USYD-ETP

DPIE Submission – SSD 8636 Modification 2, 18 September 2020

The University of Sydney (the “University”) has reviewed the City of Sydney’s comments in their letter to DPIE dated 3rd September 2020. The University provides the following detailed response. The response is to be read in conjunction with the following attachments enclosed:

Figure 2 - Precedent, tree with 20mm rock/gravel mulch, no fines

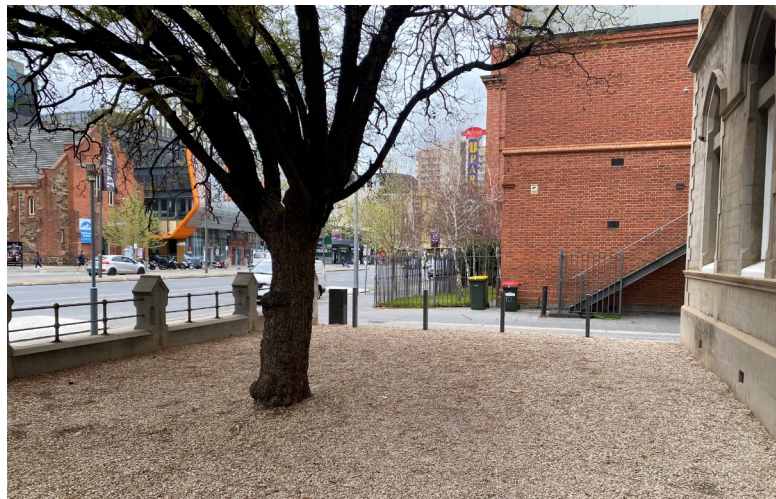
The amended Landscape Plan proposes the substitution of six *Melaleuca quinquenervia* (Paperbark) in the South plaza detention basin with six *Jacaranda mimosifolia* (Jacaranda). Jacaranda trees are an exotic semi-deciduous tree species, native to South America. Paperbark trees are evergreen trees endemic to the eastern coast of Australia. Paperbark trees naturally grow in swampy areas and are culturally important to the Aboriginal and Torres Strait Islander peoples.

The approved South Plaza plans proposed planting the Paperbark trees within a garden bed, ideal conditions for healthy tree growth and aiding in mitigation of flood water. The Jacaranda trees as shown on the proposed South Plaza plan will be planted in compact gravel, with restricted root growth by the concrete retaining walls and are situated too close together (future canopy conflicts and suppression of healthy canopies). The proposed design for the South Plaza would be a poor design outcome for supporting healthy canopy trees, contributing to the site 15% canopy coverage in accordance with Sydney DCP 2012 and aiding in the mitigation of flooding.

If the replacement of the approved *Melaleuca quinquenervia* (Paperbark) species is supported, the substitute species must be to a native tree species of a comparable mature size and within a garden bed area as detailed in the existing approved plans.

- Due to the unavailability (and issues with Myrtle Rust) of *Melaleuca quinquenervia* (Paperbark) species, substitute this for an alternate native tree species in 400Lt, *Waterhousea floribunda* 'Amaroo'. The *Waterhousea floribunda* are also more likely to form a single canopy with less suppression due to their shade tolerance.
- Replace the compacted gravel around tree planting with a porous material. We propose a 20mm rock mulch with no fines that allow maximum soil volume at 1.2m depth in accordance with Sydney Landscape Code. Example in figure 2 below.
- Garden bed to the base of each tree (min. 1.2m diameter circle)

Figure 4 - Authority owned services assets along Maze Crescent

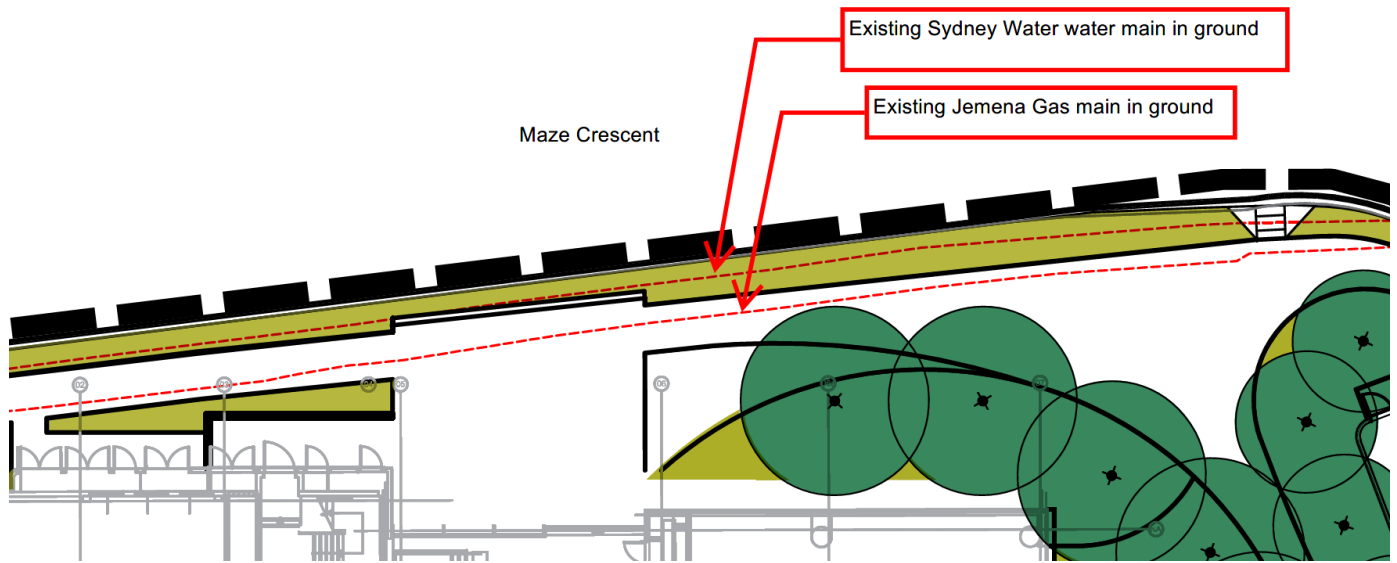
The City does not support the proposed deletion of six street trees along Maze Crescent. The six trees will provide much needed shade and aid in combating the urban heat island effect.

Street trees along Maze Crescent have been moved due to the existing authority owned services assets being directly underneath the street trees as shown in the extract below. Furthermore, the existing site gradients and Maze Crescent road levels and new DDA compliant footpaths are generating a gradient across the kerb's garden bed which in places also make it unsuitable for the street trees. Unfortunately, there isn't adequate space to achieve appropriate clearance and appropriate grade to accommodate these trees along Maze Crescent kerb in a way that complies with service authority requirements (Refer to figure 5 below from Sydney Water). Moving the trees further east to provide clearance will impede on the footpath and also clashes with a Jemena gas main that runs adjacent to the Sydney Water main as illustrated in figure 4 below.

Figure 8 – Proposed Soil Volumes

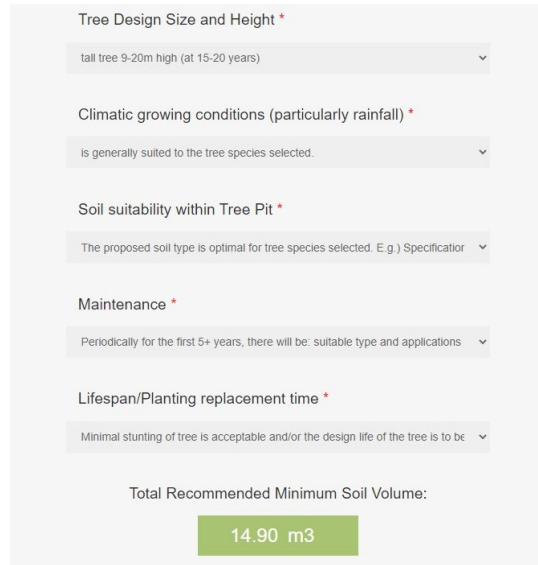
The proposed tree species within the northern landscaped area are predominantly small to medium sized trees that would reach a mature height of 10 metres. The City recommends larger canopy trees with a minimum mature height 15 metres are provided to achieve the 15% canopy coverage in accordance with the Sydney DCP 2012. The proposed raised tree planters on slab will not provide adequate soil depth to support healthy tree growth and do not comply with the Sydney Landscape Code. Consideration must be given to adequate soil availability and space (above and below ground) for all tree species to reach their full genetic potential.

Note there is no tree on slab in the Northern Courtyard (please refer to **Proposed Finishes Surfaces** plan in attachment 1 for details). Proposed trees are either in garden bed or in lawn with tree rings with min. 1.2m soil depth which complies with the Sydney Landscape Code. Soil areas are limited due to the nature of relatively small spaces between the buildings, DDA compliant walkways and internal road network. Refer to the attached **Proposed Soil Volume** Plan in attachment 1 for further information.

The arborist has advised that the City of Sydney Landscape Code Vol 2' soil volumes are based on 'on-structure' planters which is only applicable for the east landscape. However, it is acknowledged that sufficient soil volumes are required to enable the trees to be viable in the long term. The Simon Leake and Elke Haege Soils Volume Simulator has been used to determine the minimum soil volumes based on the site conditions and tree biological requirements. The average volume per tree is more than 31m³ which is above the min. 15m³ per tree in limited urban space calculated by the Leake & Haege's soil volume simulator as shown in figure 9 below. Tree roots can further spread between adjacent garden beds and pathways between garden beds with minimal pavement surface depth and sub grade compaction.

Figure 10 - accessible eastern landscape

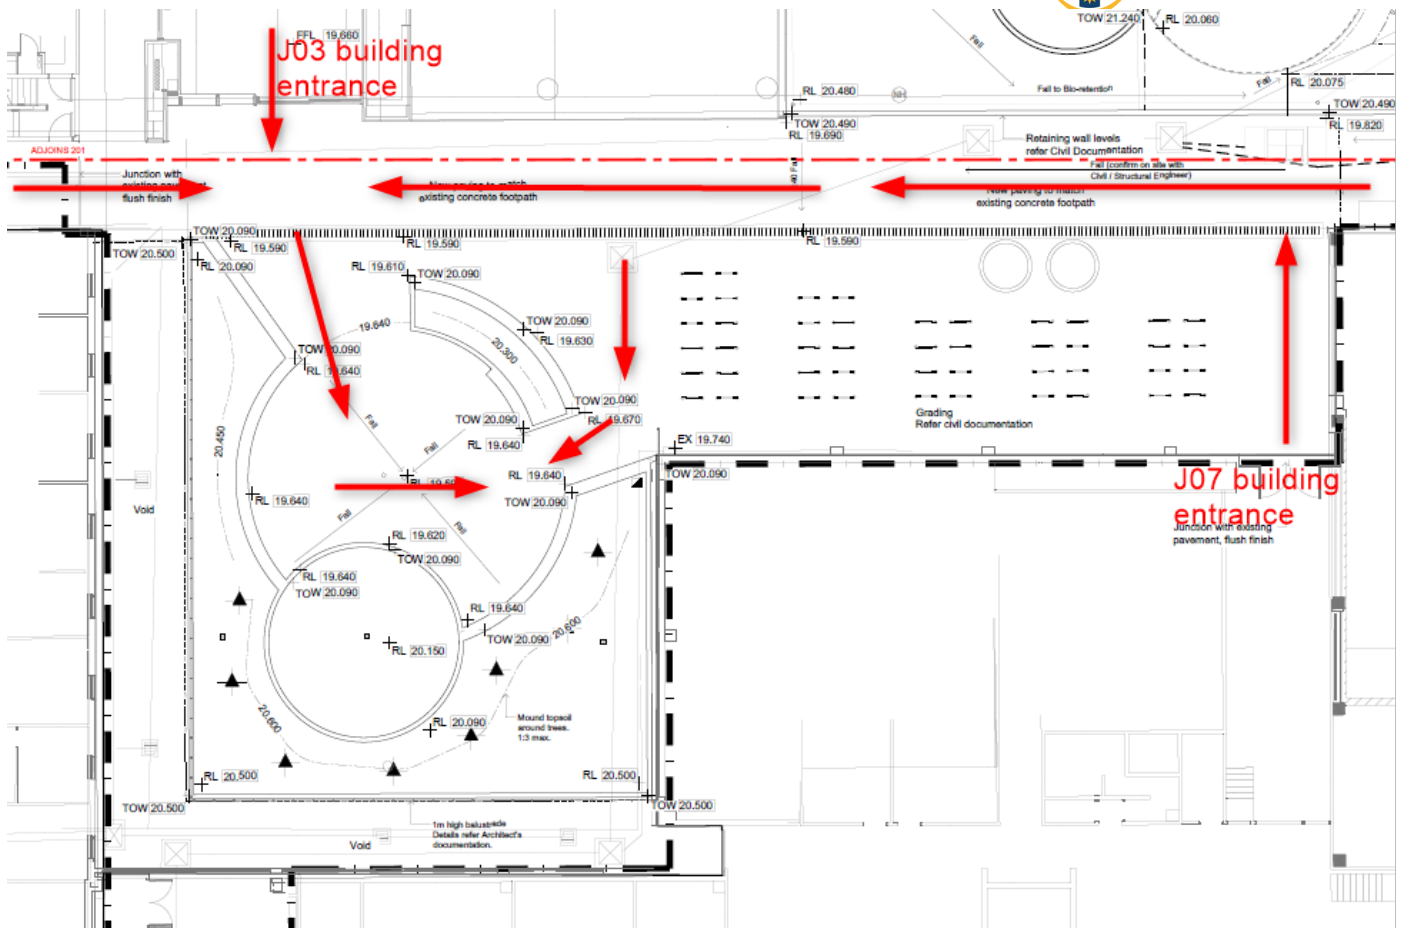
Changes to the East plaza include rationalisation of the layout and addition of a new glazed awning (3.5-4m high) to engineering walk for users accessing the bike racks that segregates the landscape from the building. It's unclear if the seating walls will be accessible for students to sit and learn outdoors or now just a space that's viewed from the building.

The Eastern Courtyard layout hasn't changed, and this courtyard is an outdoor learning and social space with seating walls at 450mm high and lawn that is accessible to students via the Engineering Walk which connects to all the 3 courtyards together to adjacent building entrances of J07, J13, J03, PNR and connects other buildings within the precinct. Figure 10 below is an extract from the updated landscape drawings in attachment 3 illustrating that the layout is fully accessible to students and DDA compliant. Note that the bike rack layout has been revised to improve circulation and efficiency of the space. Figure 11 and 12 show the area in 3D for clarity.
